Product Discontinuation Notice

Discontinuation of Generation 1 E-Stop and Stop Switches

Series 84

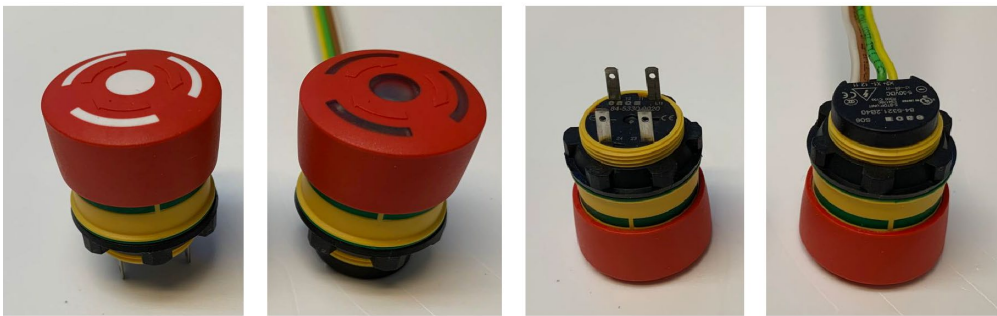
It offers many advantages over the Gen. 1 version first launched 20 years ago in 2004. The Gen. 2 version offers an improved, more rugged construction, a higher mechanical lifetime and increased environmental IP protection.

The Gen. 2 is a 'form and fit' replacement, with identical approvals. For traceability it is supplied under a new part number and can be easily identified by its black plastic connection base plate rather than the brown base plate of the older versions.

Version	IP Rating	Mechanical Lifetime	Construction of mushroom cap	Plug-in /Solder Terminals
Generation 1	IP65, IP66	50,000 cycles	3-part assembly	Tear drop hole
Generation 2	IP65, IP66, IP67	250,000 cycles	Single part assembly	Round hole
